## TEXAS COMMISSION ON ENVIRONMENTAL QUALITY

NAME OF PROJECT: The Enclave at Westpointe Village; Located at the southwest corner of Oak Run Pkwy and Independence Drive, New Braunfels, Texas

TYPE OF PLAN: Request for the Approval of a Water Pollution Abatement Plan (WPAP); 30 Texas Administrative Code (TAC) Chapter 213 Edwards Aquifer

The following is our response to the review comments received from your office dated November 1, 2010.

**EXH**

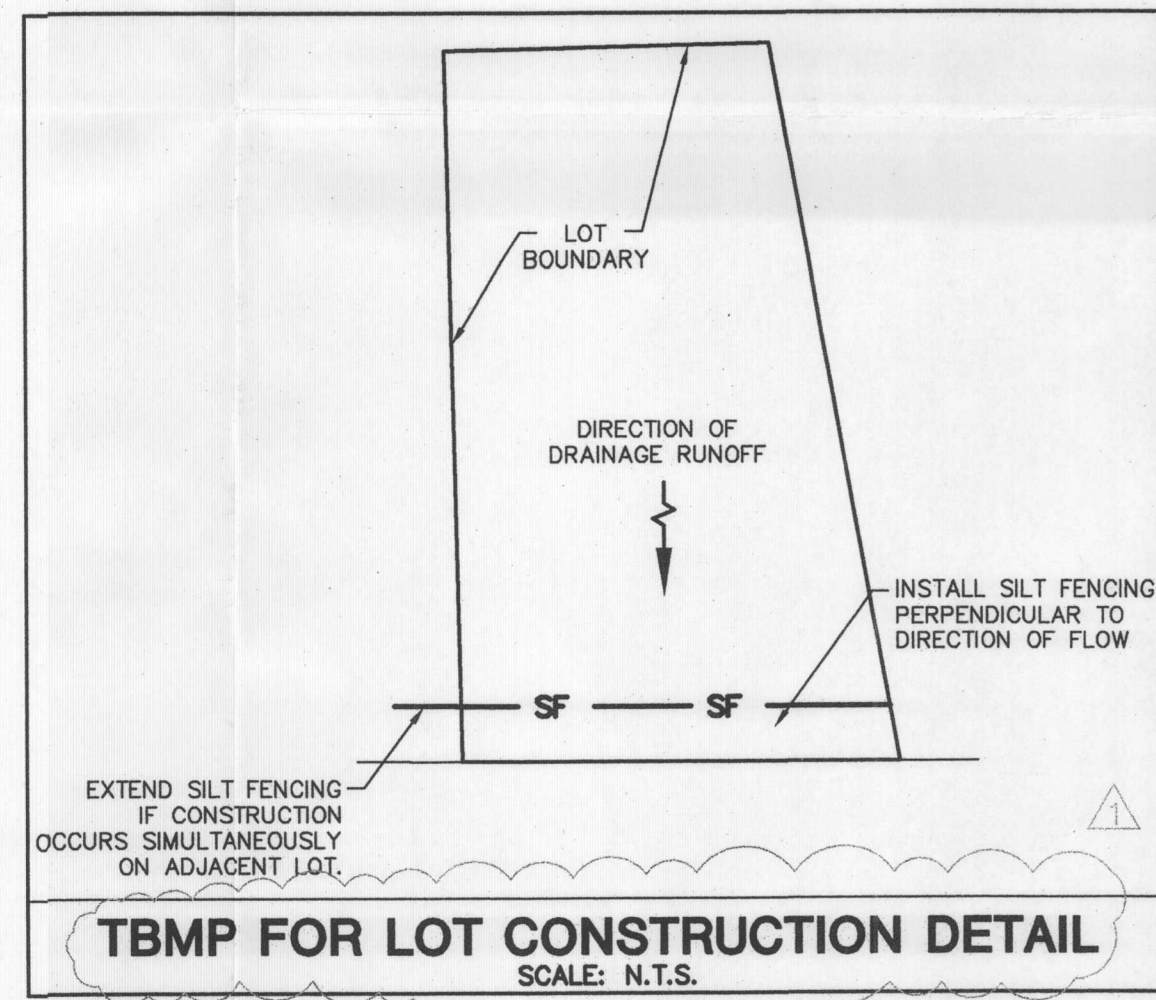
5. *Comment: Label any uncaptured areas on the drainage area map and update. Any uncaptured areas should not be included within the basin drainage areas. If impervious cover is uncaptured and untreated, the TSS amount from that impervious cover can be accounted for in a basin. Increasing the TSS amount treated by the basin in Step 5 of the sizing calculation spreadsheet.*

6. ***Comment:** Review the drainage area map. There appear to be areas included in a drainage area that either drain to adjacent drainage area or are uncaptured, more specifically, contour line and flows do not agree with drainage boundary lines. Please revise the map and basin sizing calculation as necessary.*

- a) *Based upon contours, there appears to be storm water flowing onto Westpointe Drive from Oak Run Pkwy. As part of the original Westpointe development, TSS from this parkway is treated by the existing sand filter basin at the northern corner of the site. Either revise the intersection design to have storm water flow, from the parkway, continue to the existing sand filter basin or account for the parkway TSS in the WPAP.*
- b) *At the boundary between DA-1 and DA-2, there appears to be storm water flowing along the roadway from DA-2 into DA-1.*
- c) *At the boundary between DA-1 and DA-3, there appears to be storm water from DA-3 that flows into DA-1 and therefore, is not captured by the SW basin.*
- d) *For DA-3, the roadway appears to be at a lower elevation than the inlet to the basin and storm drains are not provided.*

**Response:** There is a 3.91-acre area on the northwest corner of the project site, adjacent to the existing residential neighborhood that will not be treated. The impervious coverage in this area has been added to the Summary Tables on the WPAP Calculation Sheet. The TSS load and volume requirement for this area has been accounted for with the over treatment provided by the three water quality ponds, as well as the increase in the desired TSS treatment in Step 5 of the TCEQ Calculation Spreadsheet for each pond. The surplus load treatment and volume is shown to be greater than the volume and load removal required by this 3.91 acre portion of the project site.

**Response:** There will be water flowing from Oak Run Parkway onto Westpointe Drive. Drainage Area 2 (DA-2) has been revised to reflect the additional drainage from Oak Run Parkway. Also, the contours between DA-1 and DA-2 do depict cross flow between the two drainage areas. The future addition of two curb inlets at this junction will prevent runoff from DA-2 from entering into DA-1. These inlets are not shown as the plans for this segment of Westpointe Drive have not been designed. Such plans will be part of Phase II of the project. As noted during our meeting on November 9, 2010, a future pond system will be connected in series to a pipe leading to the proposed East Water Quality Pond. As discussed, the before-mentioned inlets will connect to that pipe. Please note that the pond system is designed such that the water upgradient from this drainage basin would be treated and detained by a future water quality and detention pond prior to being conveyed through the pipe. In addition, the boundary between DA-1 and DA-3 has been revised to match the proposed high point along Westpointe Drive; however, we have removed a portion of the roadway from DA-3. Once this segment of Westpointe Drive is designed in the future, a separate WPAP will have to be submitted for this segment of the roadway as well as the portions of the adjacent tract to the south that are not included in this application.

**Response:** The boundary between DA-1 and DA-3 at the western corner of the site has been revised to match the high points shown. Furthermore, the house lots on the outside of the internal roadway are now labeled as an area not captured. The volume and load removal requirements are satisfied through overtreatment and capture by the proposed water quality ponds. Calculations are provided and shown on the WPAP Calculation Sheet.

**Response:** As previously mentioned, the house lots on the outside of the internal roadway are now part of and labeled as an area not being captured. The volume and load removal requirements are satisfied through overtreatment and capture by the proposed water quality ponds. Furthermore, the westernmost segment of Westpointe Drive has been removed from DA-2 and will be treated by a separate WPAP submittal once design and development of this area commences.

# TEMPORARY SEDIMENTATION BASIN NOTES:

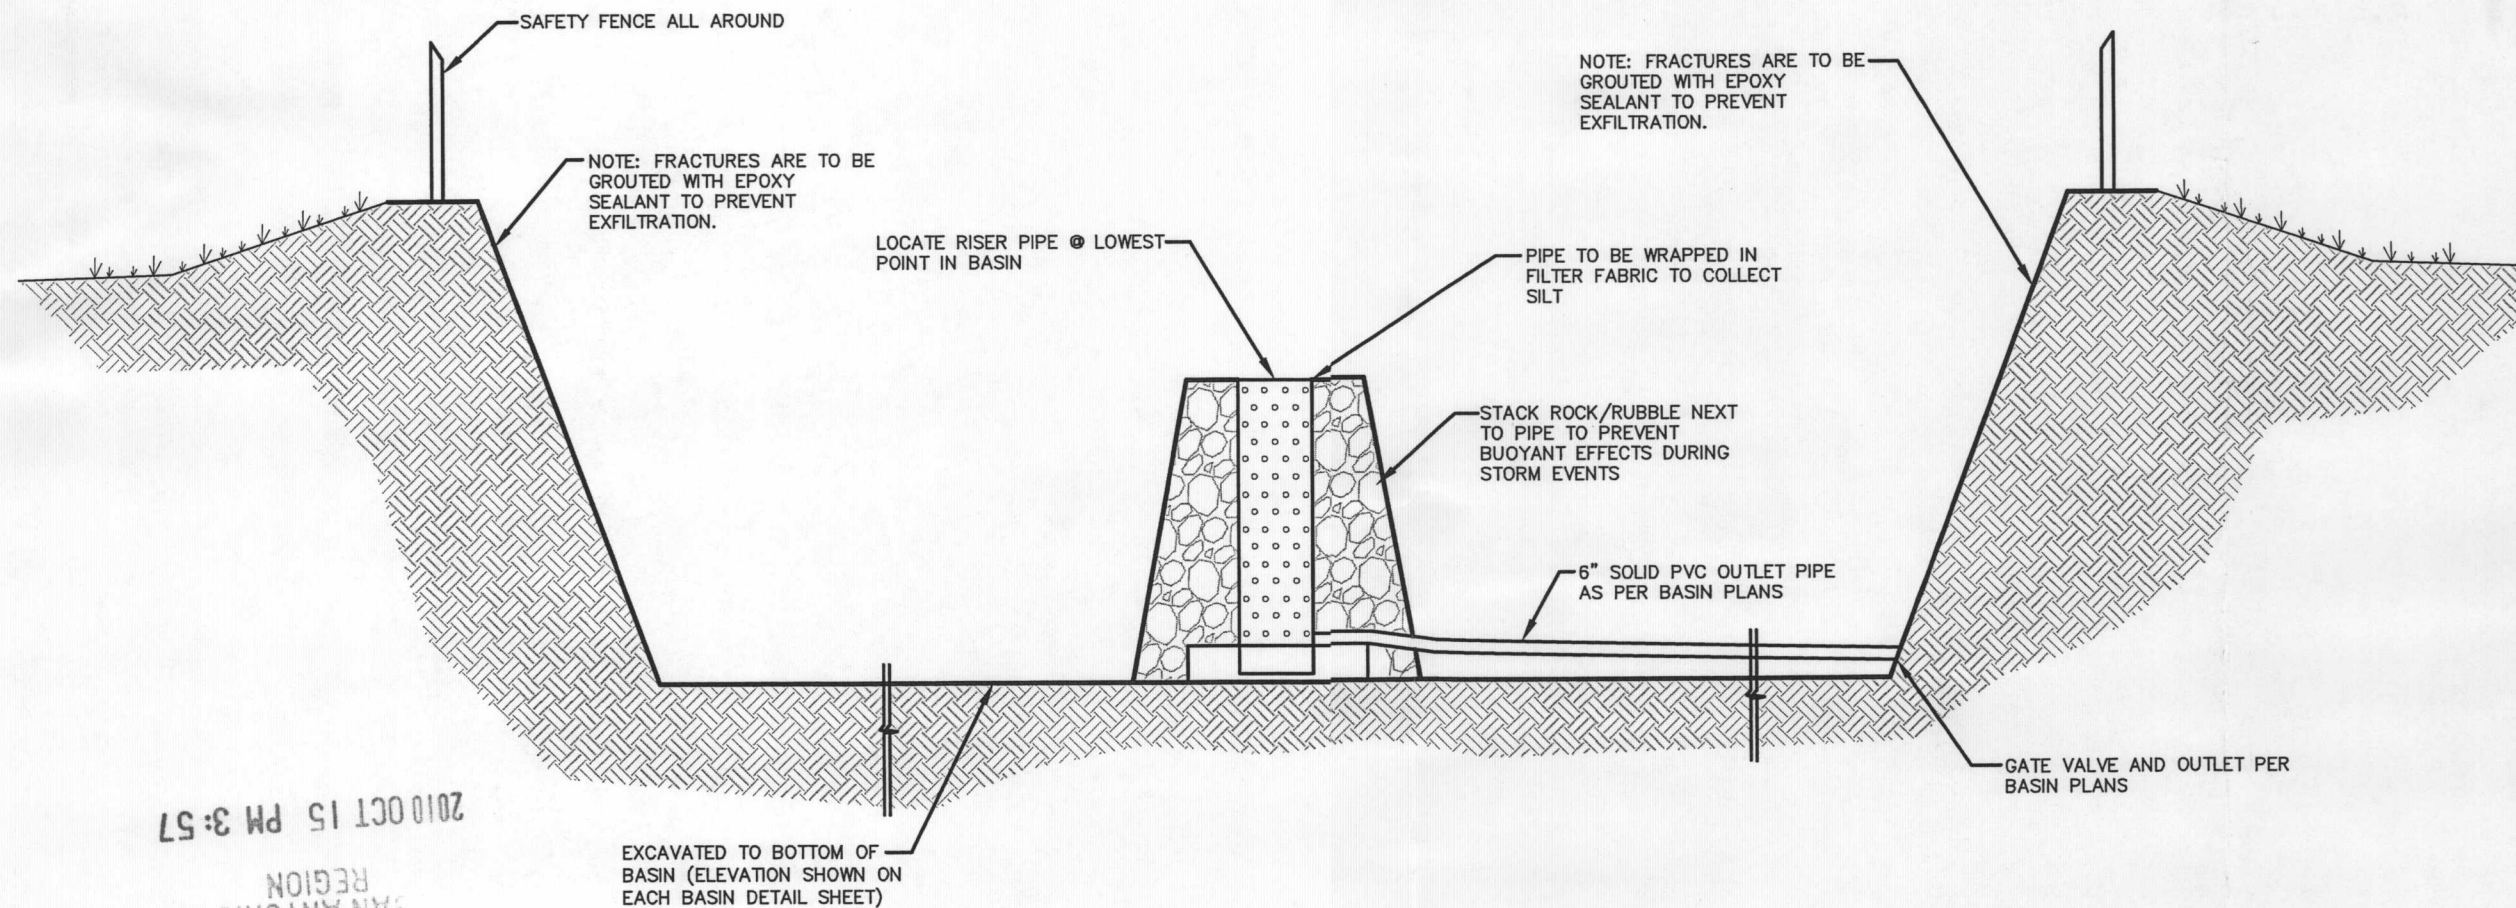
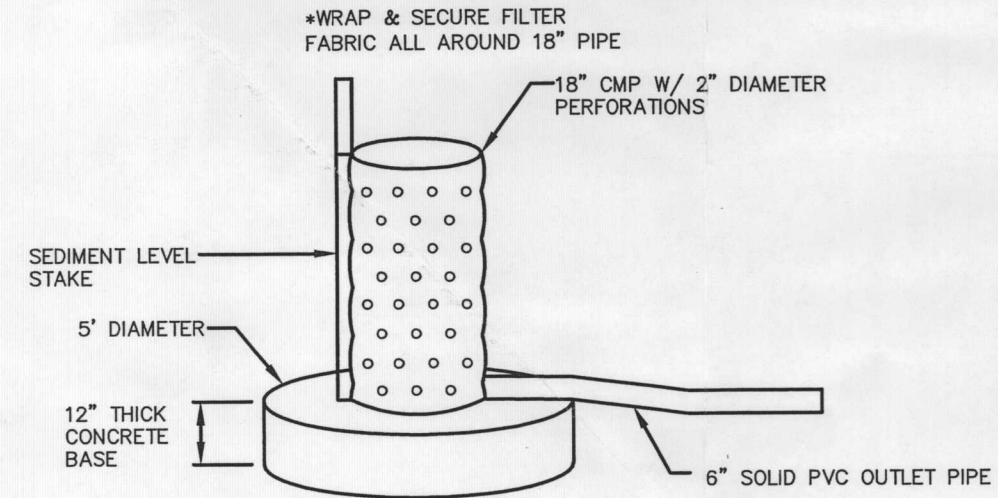
13. **Comment:** *The sizing of temporary sediment ponds is based upon the volume of runoff or 3,600 cubic feet of storage per acre drained. The statement on the Temporary Sedimentation Basin Exhibit that the total volume of the three temporary sedimentation basins exceeds the required amount (calculated from 31.37 acres) is not sufficient. Describe the amount of area disturbed in each separate drainage area then determine if the individual temporary sediment ponds are sufficient sized based upon the individual drainage areas.*

**Response:** The sizing of the Temporary Sedimentation Basins is as follows, utilizing the disturbed acres:

A revised exhibit for the Temporary Sedimentation basin is included with this letter.

C13.04.6 POND IN-FLOW DISSIPATOR PAD  
SCALE: N.T.S.

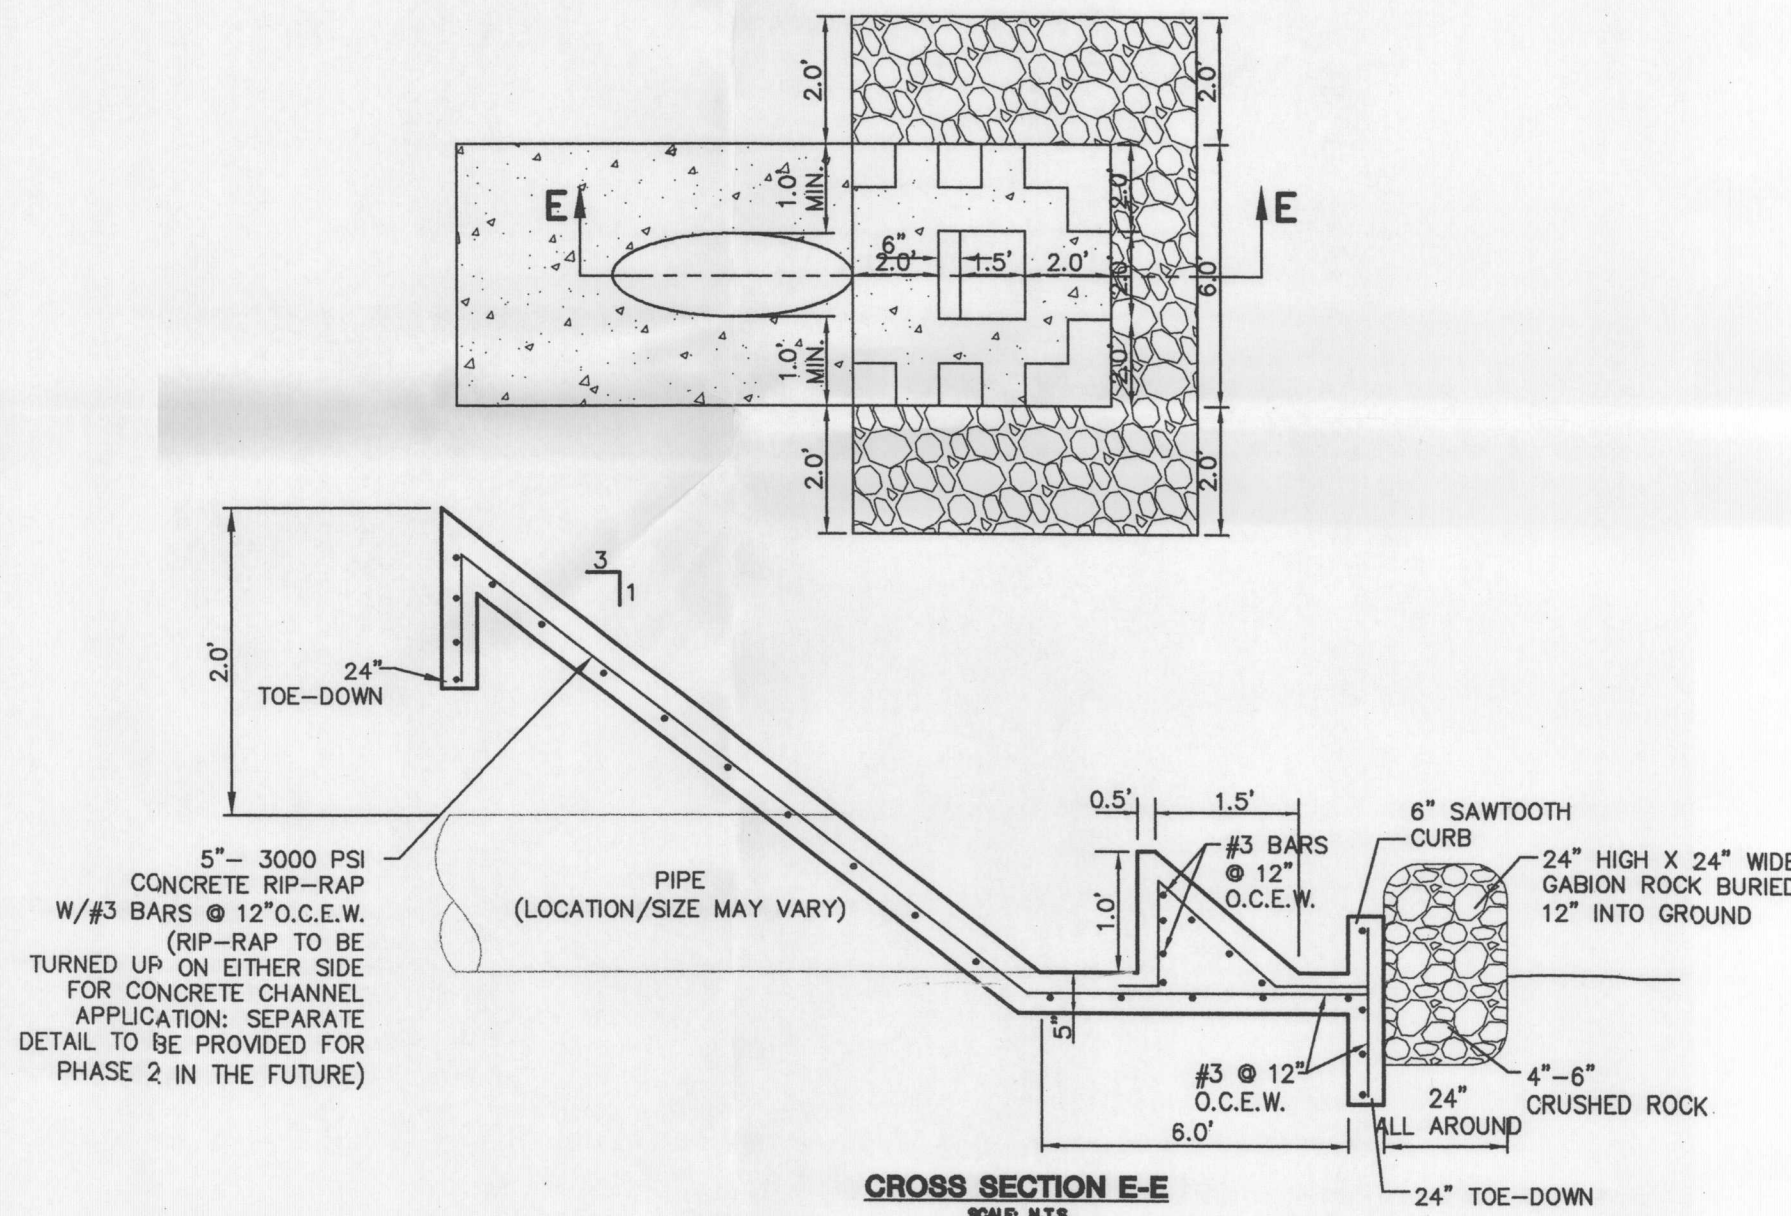
16. *Comment: Is the inlet structure leading into the west basin a pipe or a trench? The structure appears to be a trench but the Pond In-Flow detail displays a pipe leading into the basin. Are the dissipater pad and concrete blocks sufficient in preventing erosion of the sand media from a 5 foot wide trench instead of a smaller opening from a pipe?*

**Response:** The inlet structure leading into the west basin is a channel. We have updated the detail to show both pipe and channel leading into the basin. Furthermore, the dissipater pad is sufficient to prevent erosion of the sand media at the point of discharge from the channel opening.
